# Access Compliance Report

## Public Rights-of-Way

Intersection ID: 3857	Main Street: MOUNTAIN_PARK_DR	Cross Street: MOUNTAIN_TRAIL_DR	Location: SW
ADA ID: 959041E337DB	Ramp Type: PerpDiag	Initial Pass/Fail: Fail	Overall Compliance: No
Severity Score: 13.75			
Codes/Mitigation Info/Possible Solution		Field Measurements/Component Compliance

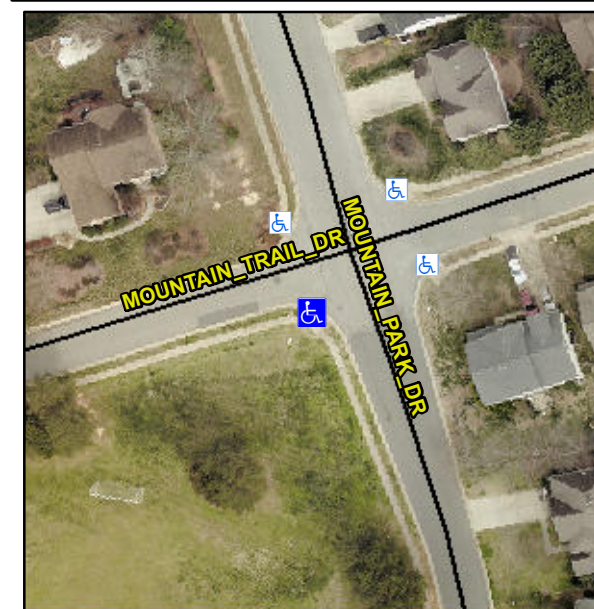
**Not Found, R304.2.2, R304.5.3**

Compliance	Description	Data	Compliance	Description	Data
N/A	Ramp Length (in)	48.0	No	Ramp Slope (%)	8.4
Yes	Ramp Width (in)	48.0	No	Ramp XSlope (%)	3.8
N/A	Flare Type LT	N/A	N/A	Flare Type RT	N/A
N/A	Flare Slope LT (%)	N/A	N/A	Flare Slope RT (%)	N/A
N/A	Flare Traversable LT?	N/A	N/A	Flare Traversable RT?	N/A
N/A	Landing Length (in)	N/A	N/A	DWS Provided?	N/A
N/A	Landing Width (in)	N/A	N/A	DWS Contrast?	N/A
N/A	Landing Slope (%)	N/A	N/A	DWS Length (in)	N/A
N/A	Landing X Slope (%)	N/A	N/A	DWS Full Width?	N/A
N/A	Landing Curb? (Y/N)	N/A	N/A	DWS Offset (in)	N/A
N/A	Shared Landing?	N/A			
N/A	Gutter Ponding?	N/A	N/A	Gutter Slope (%)	N/A
N/A	Gutter Lip Ht (in)	N/A	N/A	Gutter X Slope (%)	N/A
N/A	Painted X Walk1?	No	N/A	Painted X Walk2?	No
	X Walk 1 Direction	To E		X Walk 2 Direction	To N
N/A	X Walk 1 Width (in)	N/A	N/A	X Walk 2 Width (in)	N/A
	X Walk 1 Slope (%)	4.3		X Walk 2 Slope (%)	1.8
	X Walk 1 X Slope (%)	0.5		X Walk 2 X Slope (%)	5.3

**Remove & Replace Curb Ramp With Two New Directional Ramps or Equivalent.**
